## **KELLY FARMS SUBDIVISION**

APPLICATION NUMBER 10 DATE May 18, 2017

REQUEST Subdivision

# DETAIL SITE PLAN

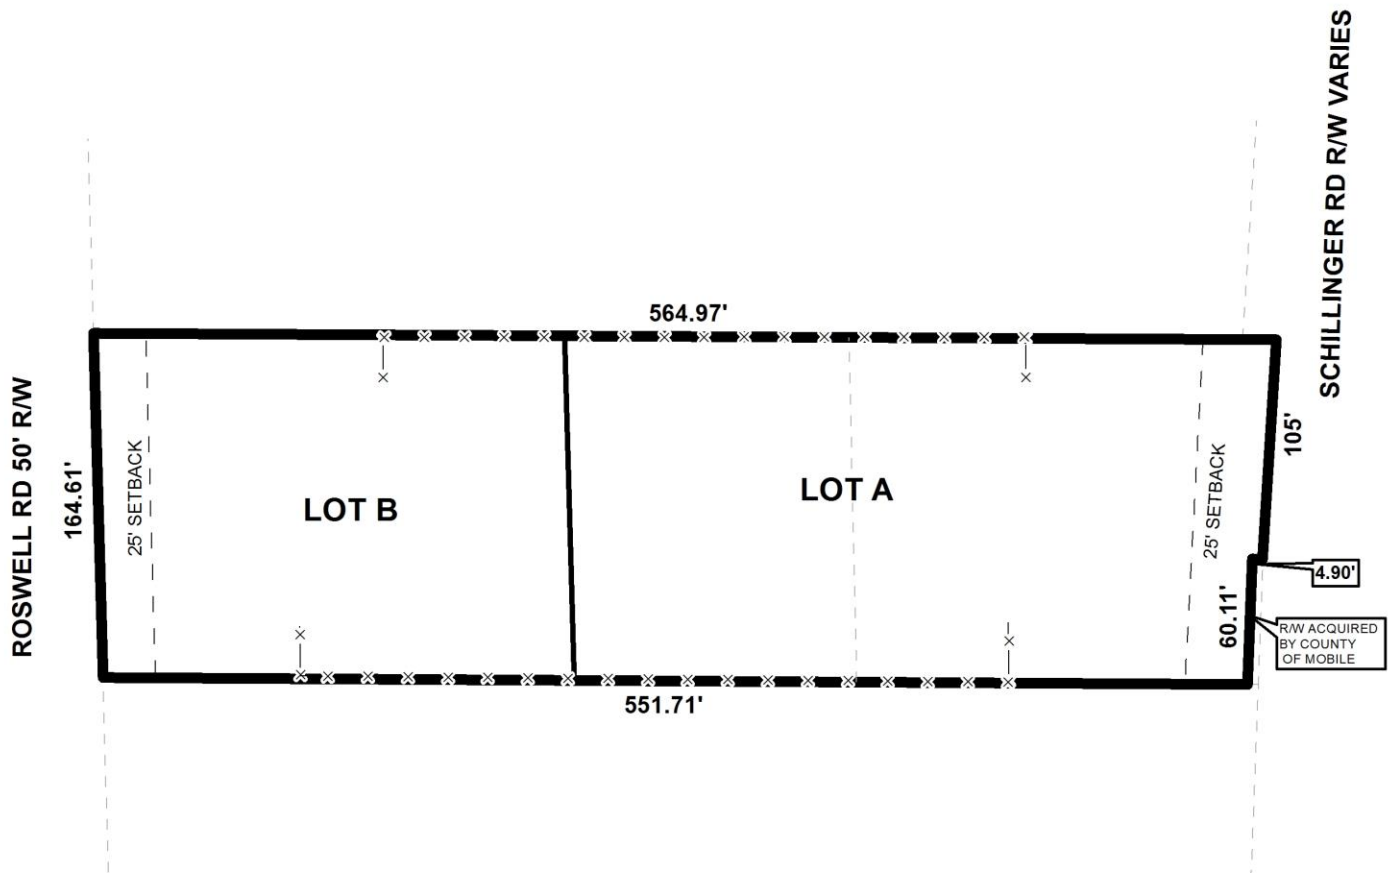
Proposed Lot A has frontage on Schillinger Road South, a major street requiring a 100' right-of-way width as depicted on the Major Street Plan; and, proposed Lot B has frontage on Roswell Road South, a minor street without curb and gutter requiring a 60' right-of-way width. A varying right-of-way is illustrated along Schillinger Road South, and a 50' right-of-way is illustrated along Roswell Road South. While a 300± square foot strip of land illustrated along the Southern portion of the frontage of Lot A was acquired by Mobile County to accommodate the construction of Schillinger Road South, the plat should nevertheless be revised to illustrate dedication sufficient to provide 50' from the centerline of Schillinger Road South, or show that the existing right-of-way is sufficient.

It should be noted that Schillinger Road South and Roswell Road South are incorrectly labeled as "Schillinger Road" and "Roswell Road" on the preliminary plat, respectively; therefore, the plat should be revised to correctly label Schillinger Road South and Roswell Road South, if approved.

The preliminary plat illustrates a 35' minimum building setback line along Schillinger Road South and the 25' minimum building setback line along Roswell Road South, both of which are sufficient to satisfy the requirements of Section V.D.9. of the Subdivision Regulations. If approved, this information should be retained on the Final Plat, adjusted for any required dedication.

Each lot meets the minimum size requirements of the Subdivision Regulations for lots served by public water and individual septic tanks, and are appropriately labeled in square feet and acres on the preliminary plat. If approved, this information should be retained on the Final Plat, adjusted for any right-of-way dedication; or, a table providing the same information may suffice.

- 1) revision of the plat to illustrate dedication sufficient to provide 50' from the centerline of Schillinger Road South, or show that the existing right-of-way is sufficient;

- 2) revision of the plat to correctly identify Schillinger Road South and Roswell Road South;
- 3) placement of a note on the Final Plat stating each lot is limited to its existing curb cuts, with any changes in their sizes, locations or designs to be approved by Mobile County Engineering and conform to AASHTO standards;

- 4) retention of at least a 25' minimum building setback line along all street frontages;
- 5) retention of the lot sizes for each lot in square feet and acres on the Final Plat, or provision of a table providing the same information;
